Six Cavity Test 8.

Gennady Romanov

January 6, 2010

Iteration 8 (received on 12/16/2009 from Bruce Popper).

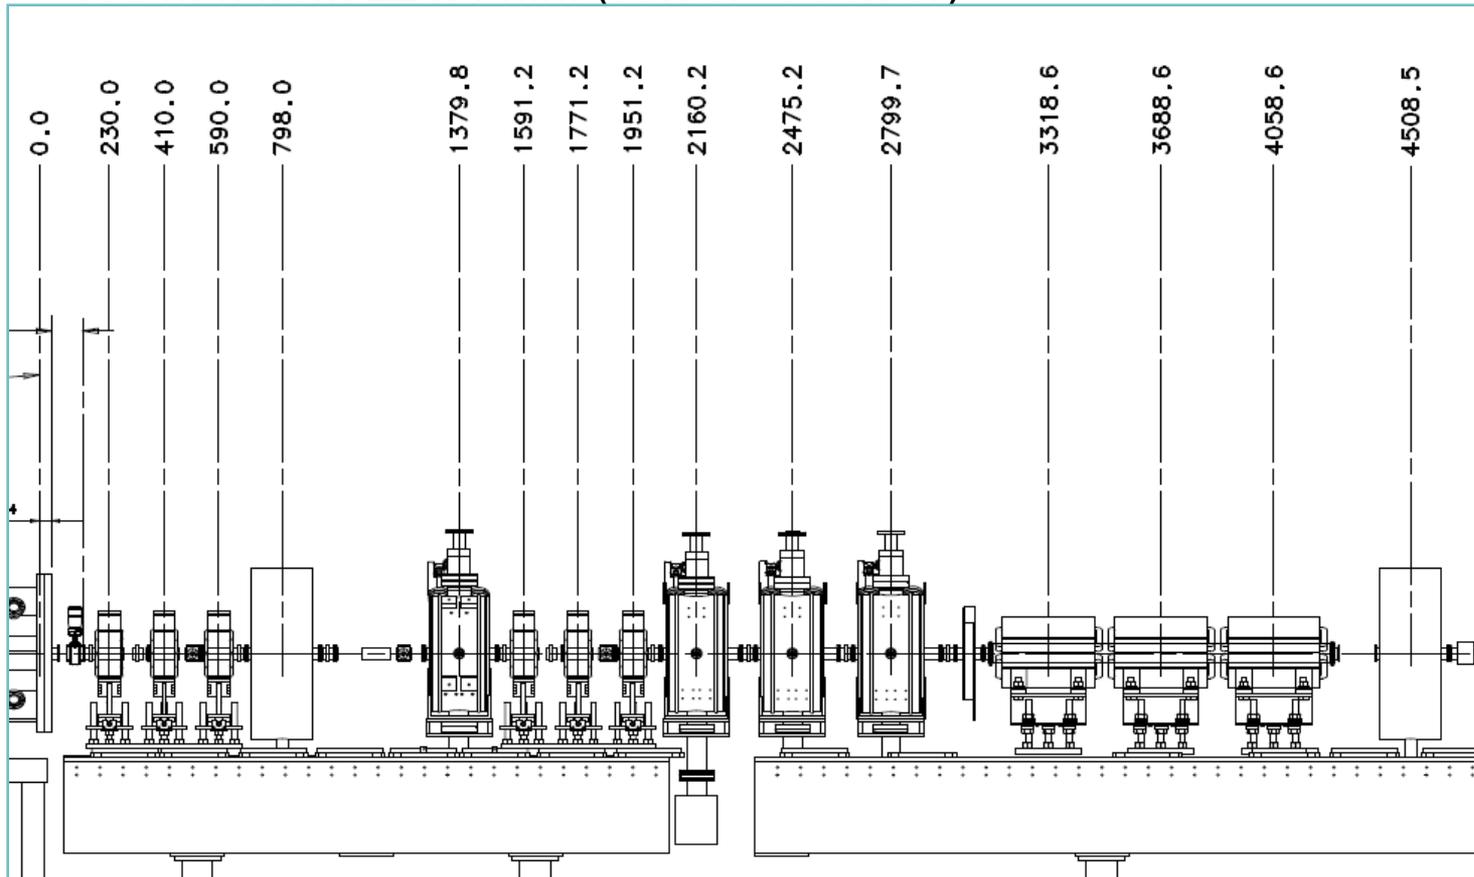
Main changes compare to v.7:

1. Distance from vane tip to first quad center is decreased from 261 mm to 230 mm (history: v.1-5 – 217 mm, v.5-7 – 261 mm, v.8 – 230 mm)
2. Distances between the centers of HEL quadrupole lenses are back to 180 mm from 221.4 mm (center to center)

Only first triplet has been retuned. (now it's close to v.3), since other changes are minor.
